## ADDENDUM #2

The Capital Area Transit System (CATS), Baton Rouge, Louisiana hereby amends the above referenced Request for Quote (RFQ) as follows:

## **CATS Official Responses to RFQ Questions**

**CATS PAVING REPAIRS AT CATS  
 MAIN OFFICE & TERMINAL FACILITY**

## PLAN OF CONCRETE WORK BETWEEN BUS WASH AND DETAILING BLDG.

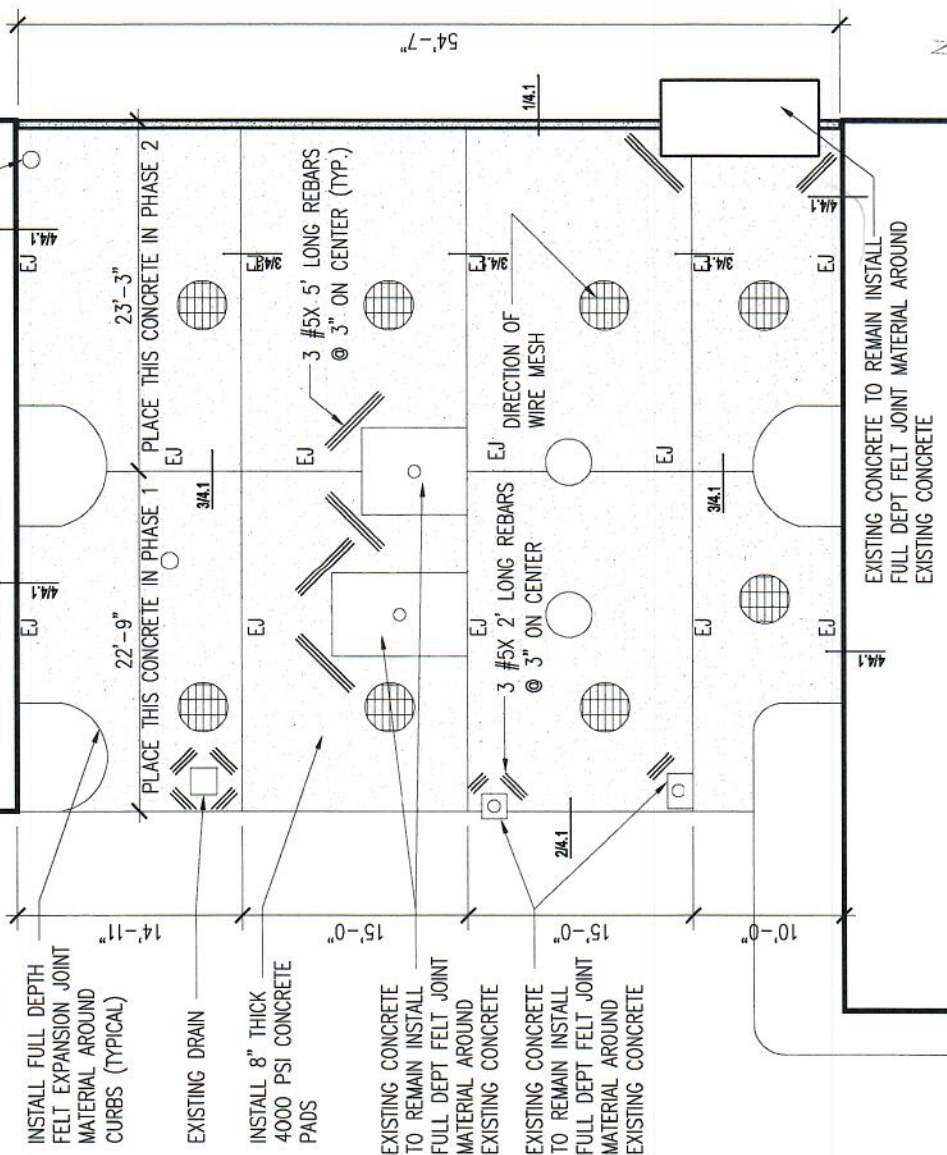
INSTALL FULL DEPTH  
EXPANSION JOINT  
MATERIAL AROUND  
BOLLARD

SECTION MARKS PLACED  
IN CORRECT LOCATION
